**CITY OF CAMBRIDGE**

Community Development Department

Re: Special Permit PB #371, 269-301 Vassar Street

Submission Type: Special Permit Application

Source: MIT Special Permit Application, 2.1 Proposed Design Massing Diagram

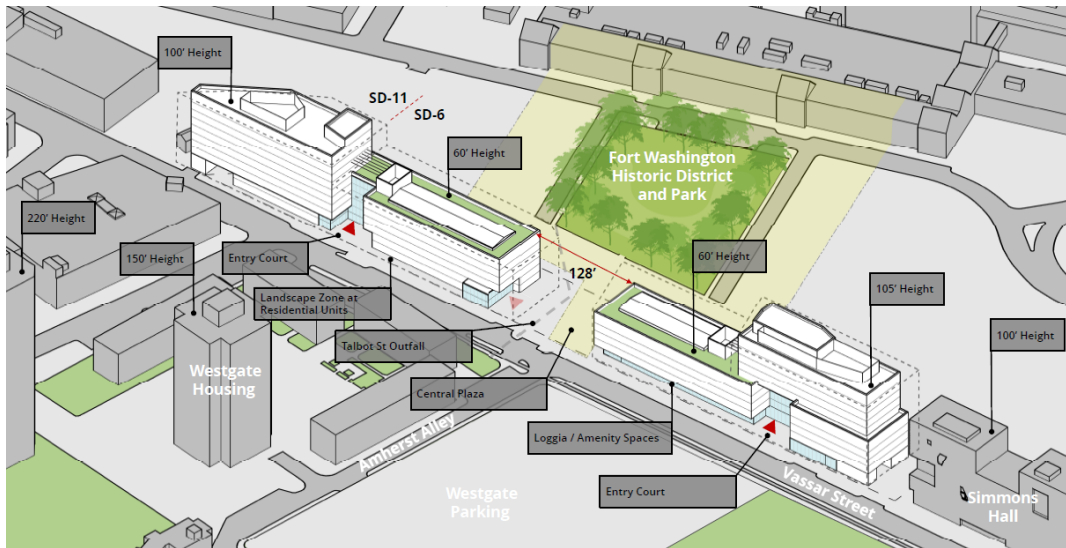
As mentioned above, the proposed development consists of an East Building and a West Building. The East Building, located closer to Simmons Hall to the north on Vassar Street, is located entirely within the SD-6 zoning district. The SD-6 zoning district generally permits building heights up to 100', but near Fort Washington Park building heights are further restricted to 60'. To counterbalance this height restriction, additional height up to 180' may be permitted by special permit from the Planning Board.

The West Building, located on the southern portion of the lot, is zoned such that approximately half of the proposed building is in the SD-6 zoning district, and the remaining half is in the SD-11 district. The

SD-11 district permits building heights up to 85', but also allows an increase to 100' through the issuance of a special permit from the Planning Board.
